### Proposed Revisions to a Standard Plans Index

Index Number: 700-090

Index Title: Dynamic Message Sign Walk-In

LAST REVISION	REVISION	DESCRIPTION:	 FY 2022-23 STANDARD PLANS	DYNAMIC MESSAGE SIGN WALK-IN	INDEX 700-090	SHEET 1 of 5
11/01/22

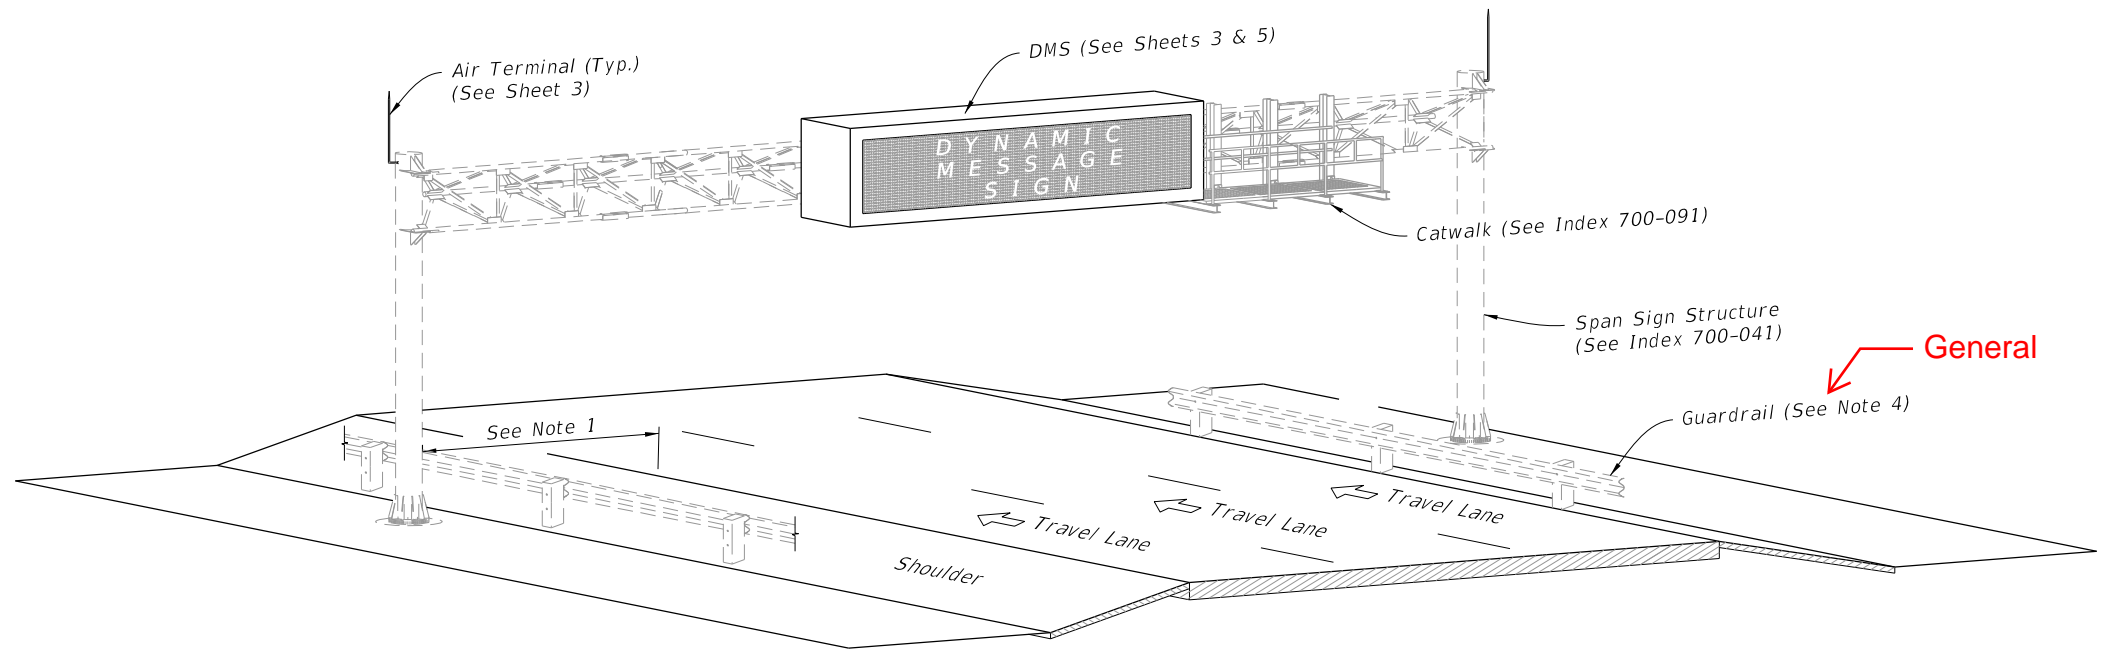
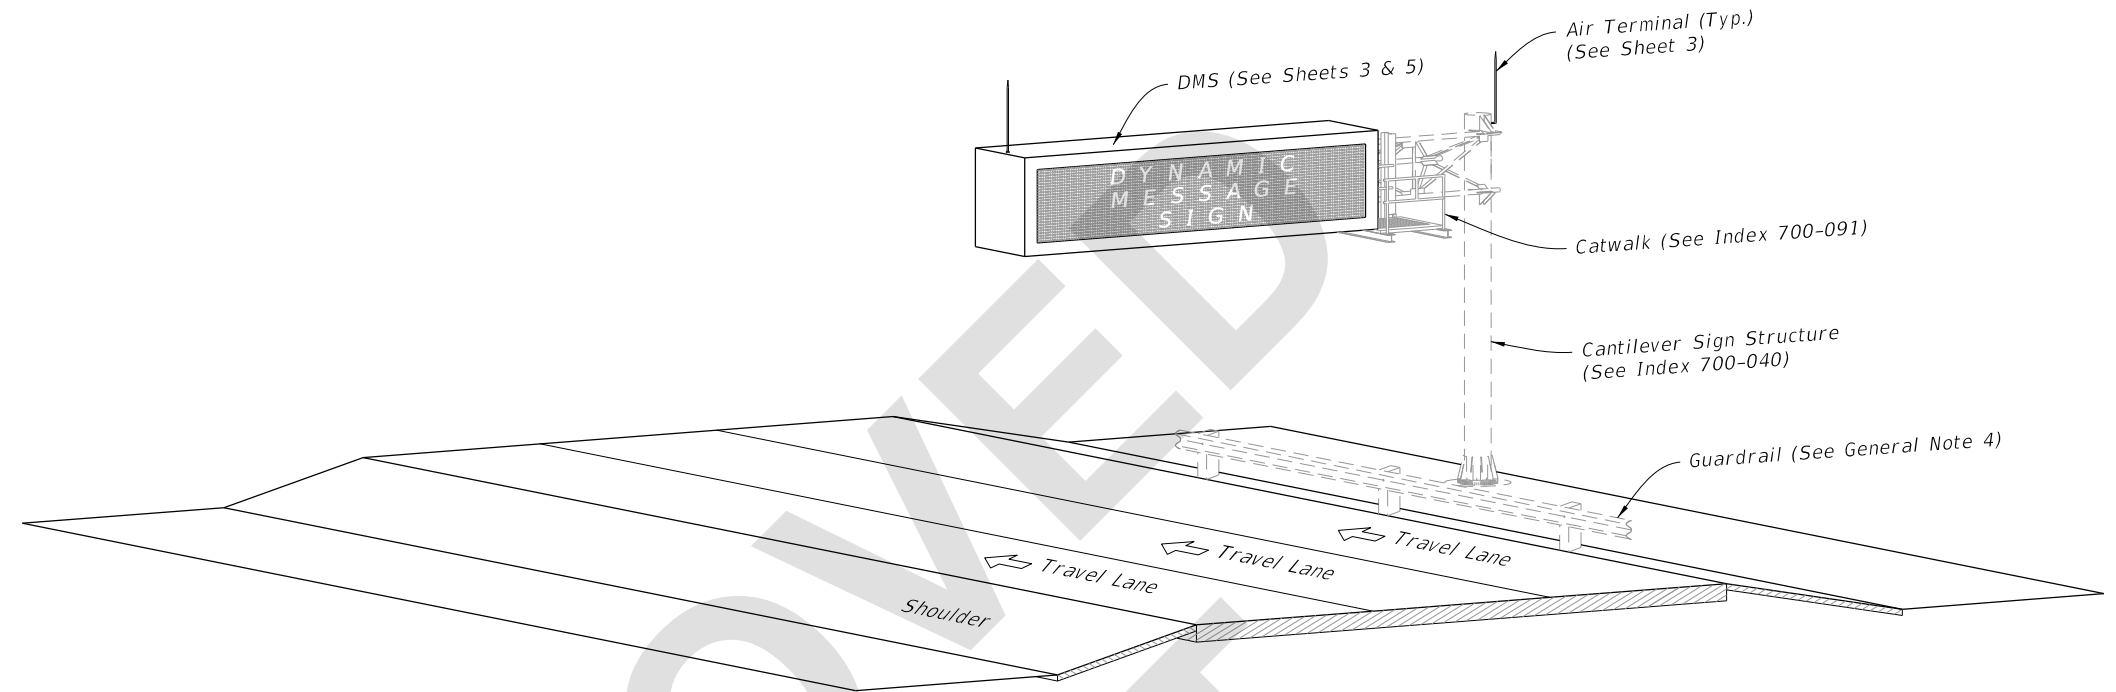
1. ~~Work this Index with Specification 700.~~
2. Furnish and install the Dynamic Message Sign (DMS), sign structure in accordance with Index 700-040 or 700-041. Locate foundations at locations shown in the Plans.

5. ~~Materials:~~
  - A. ~~Sign Mounting Components:~~
    - a. ~~Aluminum Structural Shapes: ASTM B221, Alloy 6061-T6~~
    - b. ~~Vertical Hangers: ASTM A704, Grade 36~~

- c. ~~U-Bolts: ASTM A449 or A193 B7~~
    - d. ~~Steel Bolts, Nuts, and Washers:~~
      1. ~~High Strength Bolts: ASTM F3125, Grade A325, Type 1~~
      2. ~~Nuts: ASTM F563~~

3. ~~Washers: ASTM F463 (Flat Washer)~~
  - B. ~~Coatings:~~
    - a. ~~All nuts, bolts and washers ASTM F2329~~
    - b. ~~All other steel items ASTM A123~~

- c. ~~Bolt hole Diameters: Bolt plus 1/16" before galvanizing~~

**GENERAL COMMENT: Material information was deleted. Information is either already covered in Standard Specifications OR will be added to Section 700, 962 or 965 in conjunction with these revisions.**

**UPDATED NOTE: Meet the requirements of Specification 700.**

**DELETED**

LAST REVISION 11/01/22	REVISION	DESCRIPTION:	 FY 2023-24 STANDARD PLANS	DYNAMIC MESSAGE SIGN WALK-IN	INDEX 700-090	SHEET 1 of 5
------------------------------	----------	--------------	---	------------------------------	------------------	-----------------

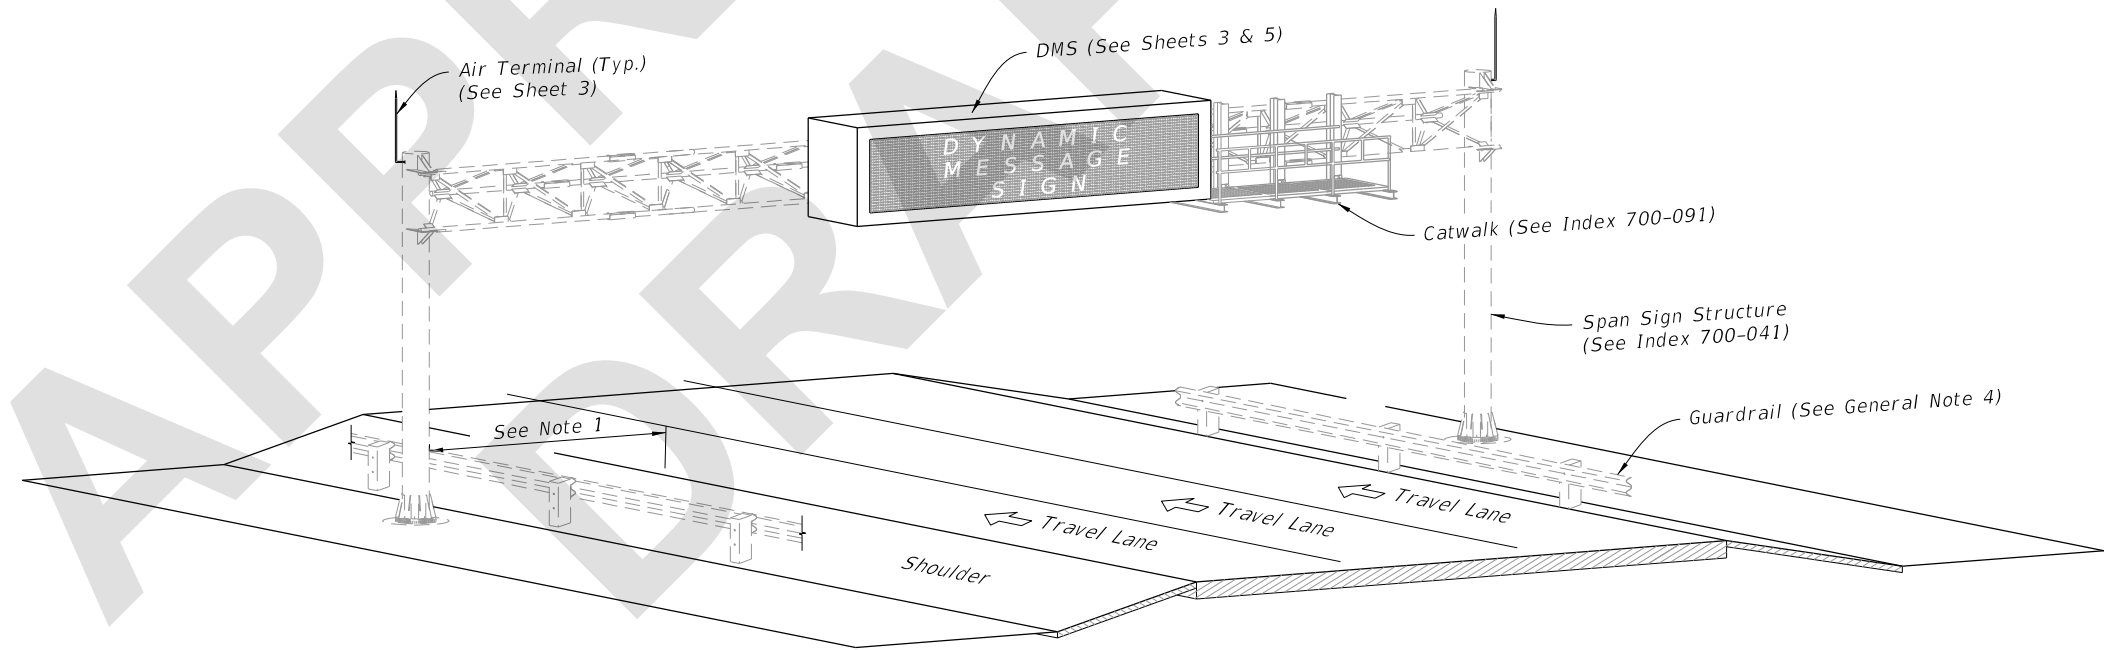
Updated General Note 1 - "Meet the requirements of Specification 700."; Deleted Note 5; Renumbered General Notes.

1. Meet the requirements of Specification 700.
2. Furnish and install the Dynamic Message Sign (DMS), sign structure in accordance with Index 700-040 or 700-041. Locate foundations at locations shown in the Plans.
